LAUREATE PARK PHASE 5 PLAT

SUMMARY

Updated: November 27, 2013

PROPOSED PRELIMINARY PLAT

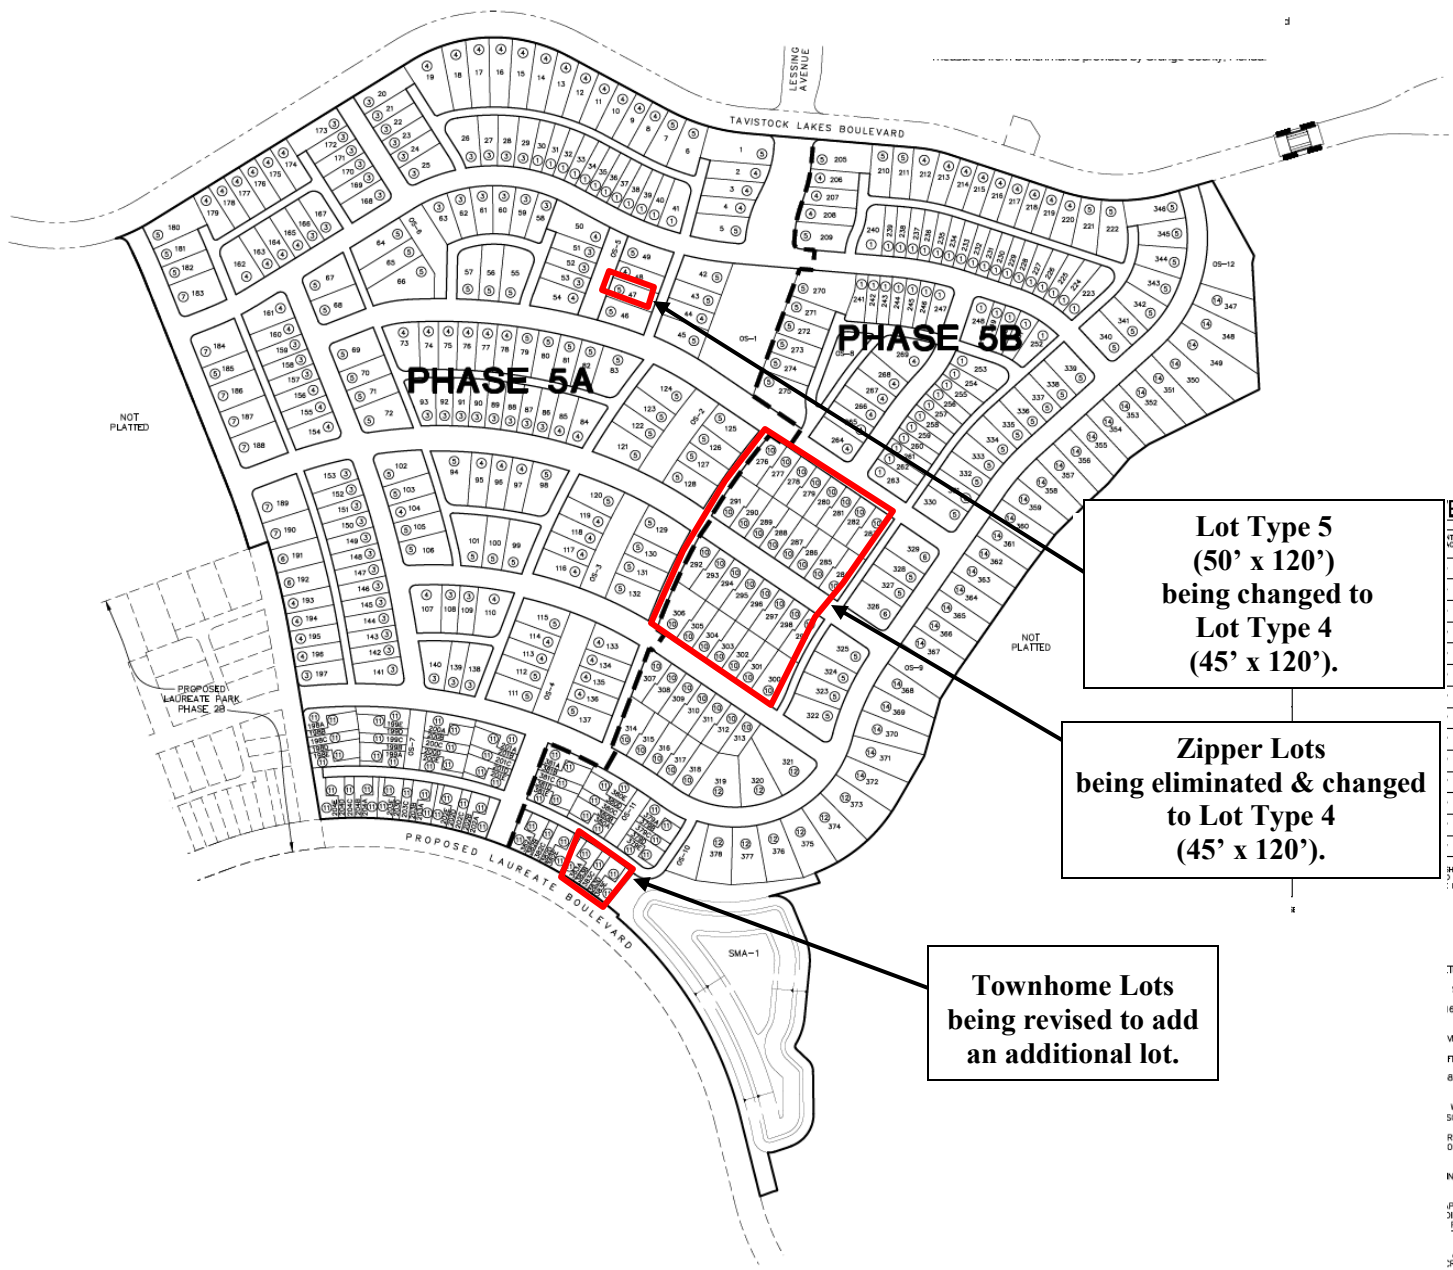
Laureate Park Phase 5 SPMP depicts a formal trail along the east side of the development adjacent to the Primary Conservation Network, which is consistent with the Lake Nona Southern Circulation Plan (MPL2011-00004). The preliminary plat does not depict this proposed trail, therefore, the final plat shall depict the 10 foot wide trail on the east side of the development from Tavistock Lakes Boulevard to Laureate Boulevard.

The Laureate Park Phase 5 SPMP addresses a trail network on the east side of the development. The preliminary plat does not depict this proposed trail, therefore, the applicant shall provide a recorded trail easement document that will allow for public access prior to the recording of the Laureate Park Phase 5B plat.

PRELIMINARY PLAT—AERIAL VIEW

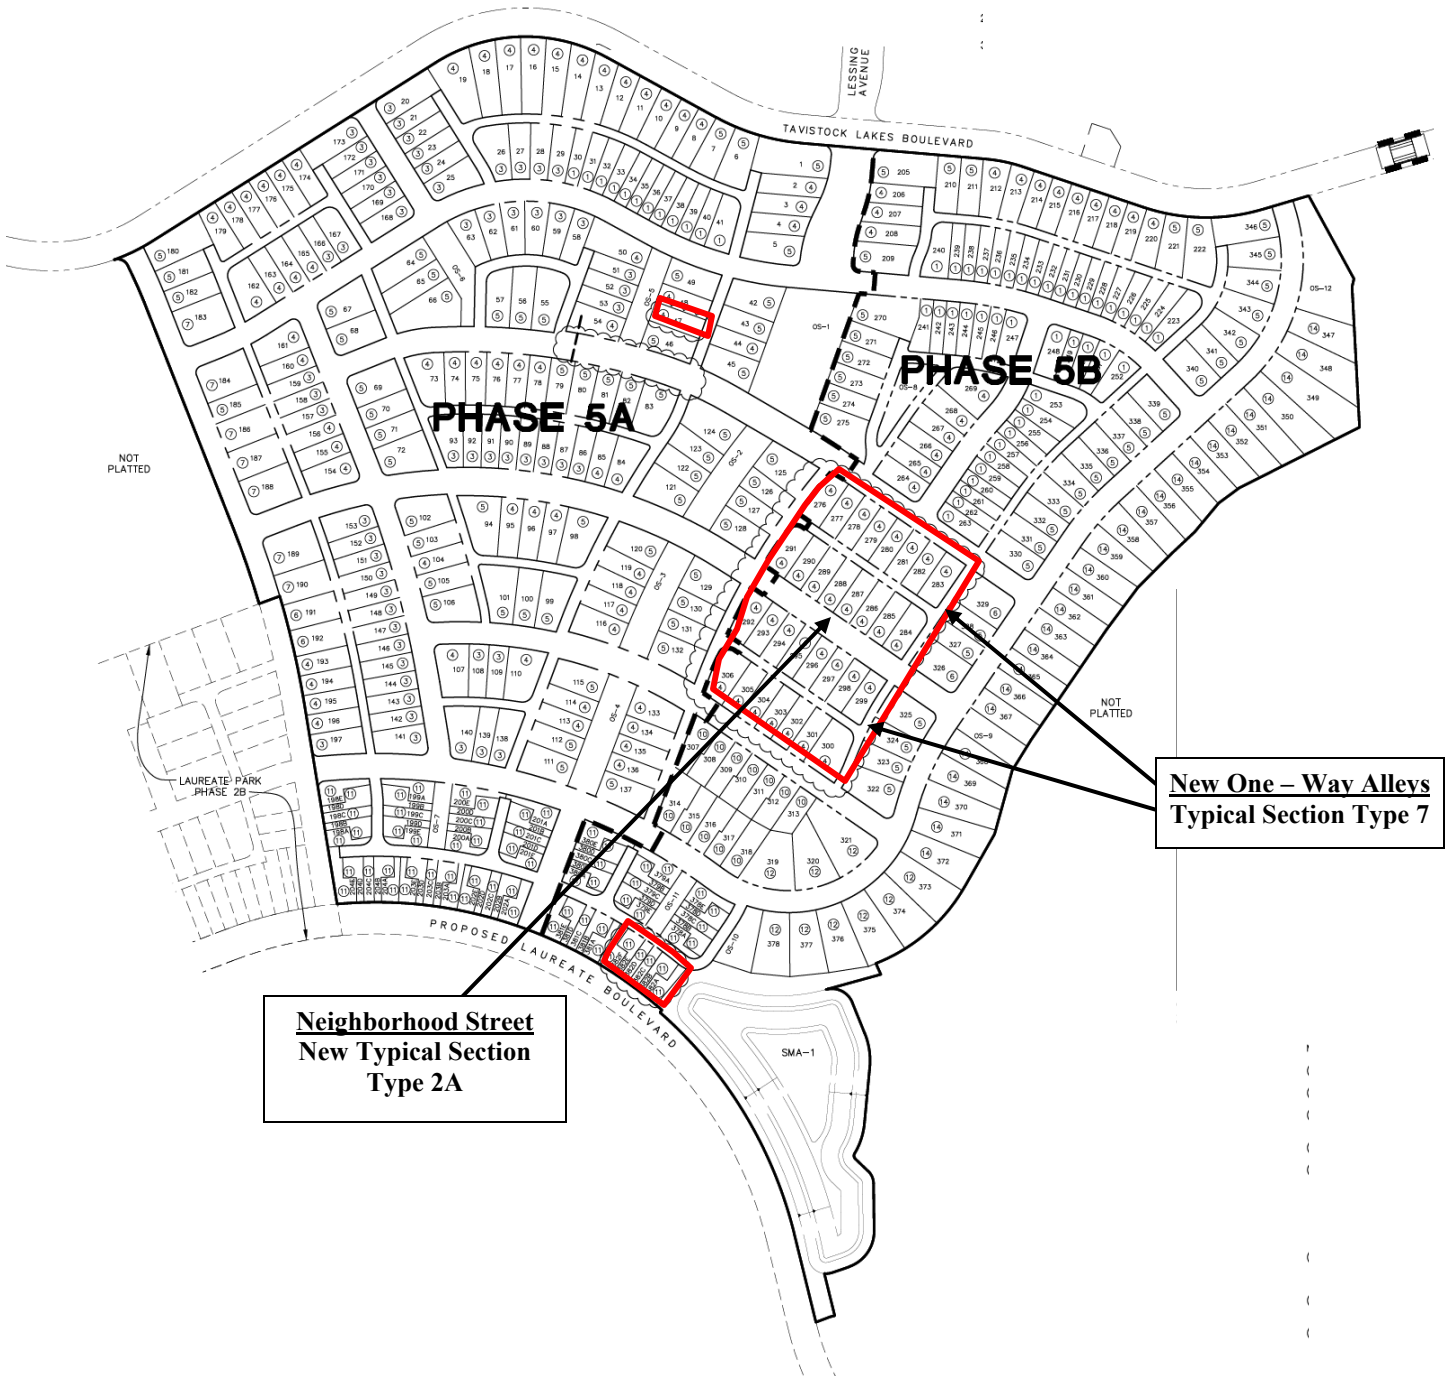
The above graphic is an overlay of the proposed plat on an aerial photo. The southern portion of the plat and the proposed Laureate Boulevard encroach into the current Primary Conservation Network to the south. After discussion with the applicant regarding this matter, it was stated that they have and are continuing to work with the South Florida Water Management District (SFWMD).

Prior to the recording of the final plat, the applicant must show evidence from the appropriate permitting agency (i.e. Army Corps and/or SFWMD) that Laureate Boulevard and adjacent lots are permitted to encroach into the current Primary Conservation Network (PCN), and that amendments to the PCN boundary have been approved to exclude this property. The applicant shall also revise the aerial/plat overlay map to demonstrate the configuration of the road and lots do not encroach into the new PCN boundary.

Prior to the recording of the final plat, the applicant must show evidence from the appropriate permitting agency (i.e. Army Corps and/or SFWMD) that Laureate Boulevard and adjacent lots are permitted to encroach into the current Primary Conservation Network (PCN), and that amendments to the PCN boundary have been approved to exclude this property.

New Cross Section

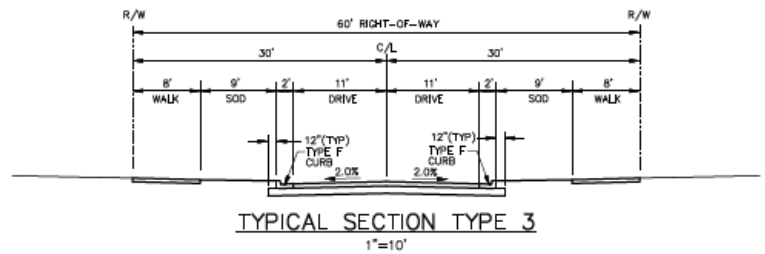
The previous submittal depicted six cross-sections for its Neighborhood Streets and three cross sections for its Alleys. The applicant has submitted the previously approved cross sections and a new cross section (Typical Section Type 2A). The replacement of the zipper lot type to Lot Type 4 has also introduced one-way alleys between the rows of lots which were not previously proposed with the zipper lot type (See Page 7 of this report). Also, some road segments have been assigned to a different cross section than previously approved. The cross sections shown on pages 9-11 depicts the cross sections with the proposed road segments.
